Address (list all addresses on the project site): 4725 Tradewinds Parkway
Title: Synbiotic Health

RE: 4725 Tradewinds Parkway
Urban Design Submittal / Upgrade

SYNBIOTIC
INTERIOR BUILD-OUT
4725 TRADEWINDS PARKWAY
MADISON, WI 53718

**NORTH
ELEVATION**

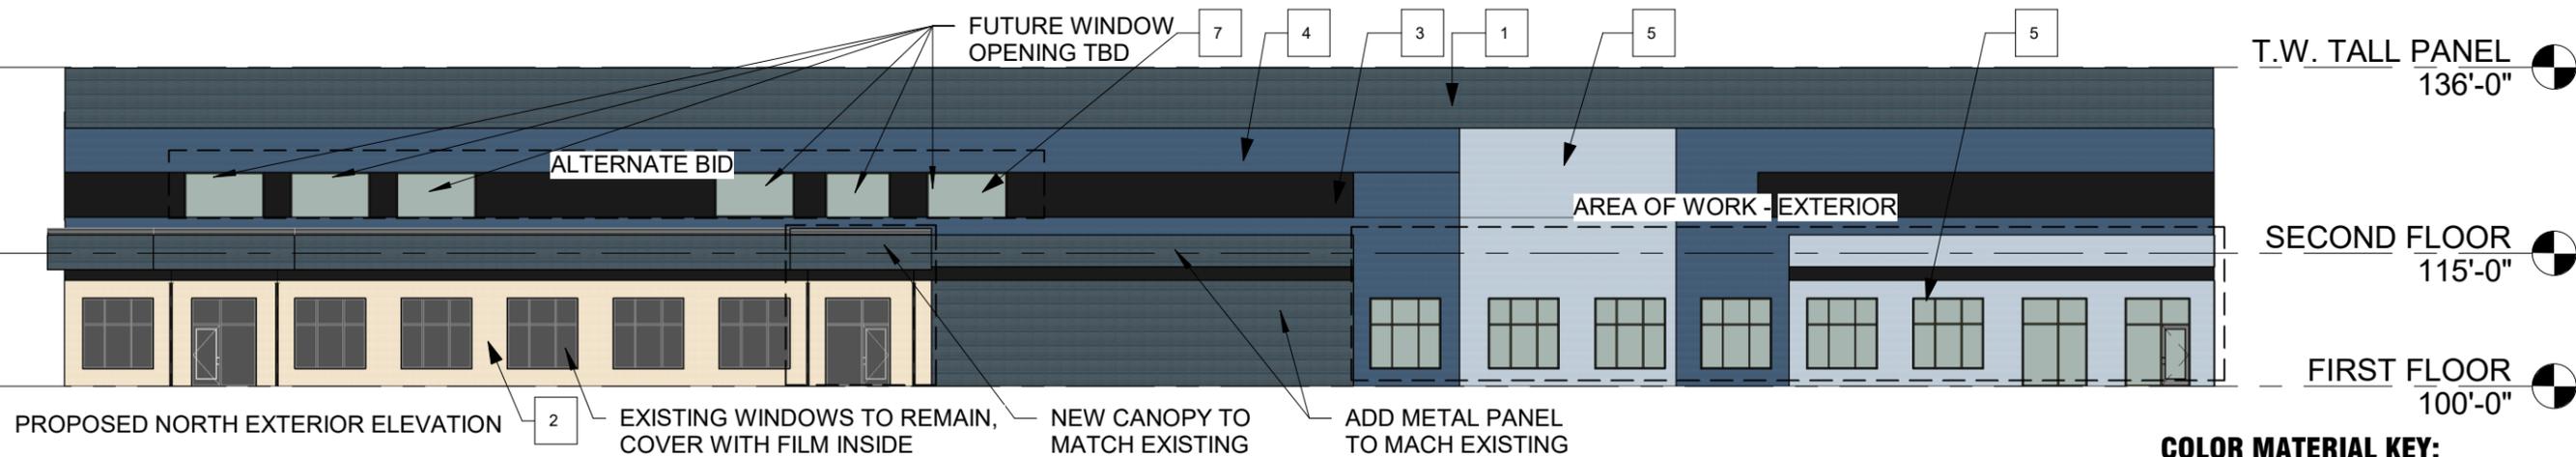
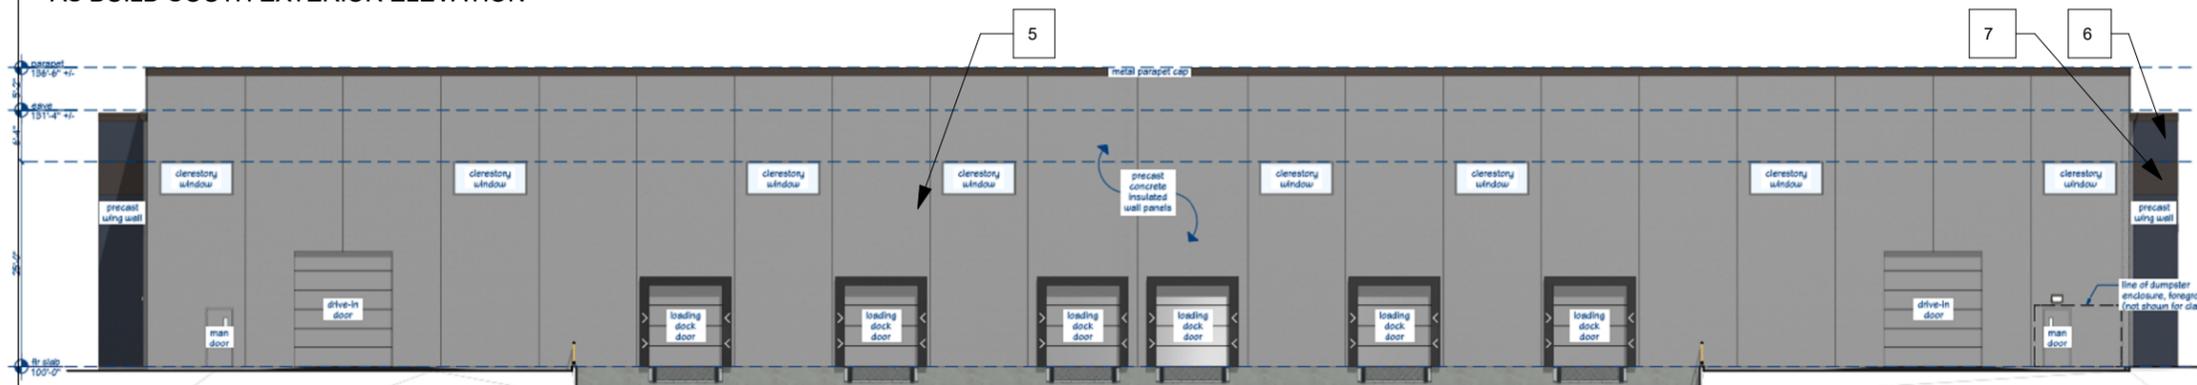
2 EXISTING WINDOWS TO REMAIN, COVER WITH FILM INSIDE
NEW CANOPY TO MATCH EXISTING
ADD METAL PANEL TO MACH EXISTING

SOUTH
ELEVATION

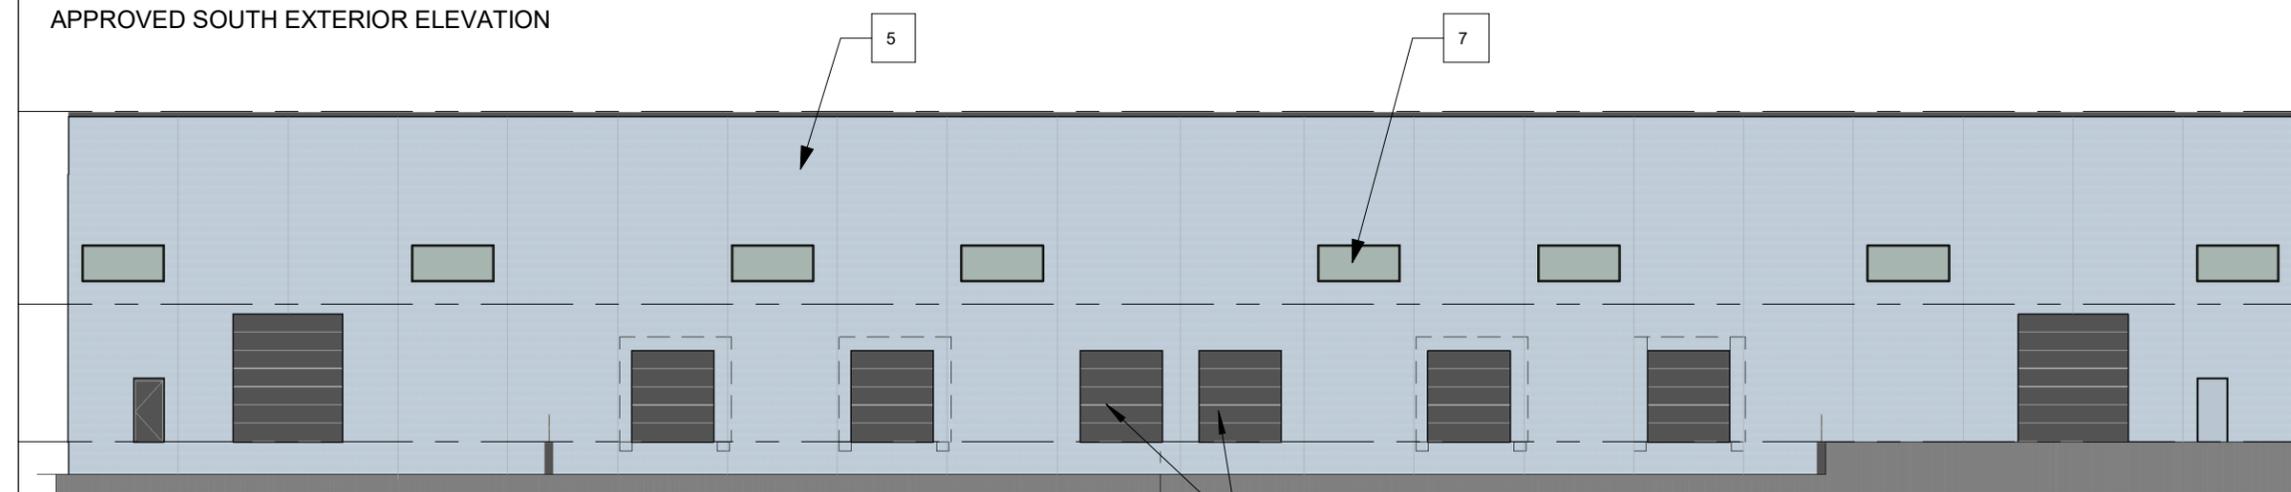
PAINT EXISTING DOOR BLACK TO MATCH COLOR DOCK DOORS
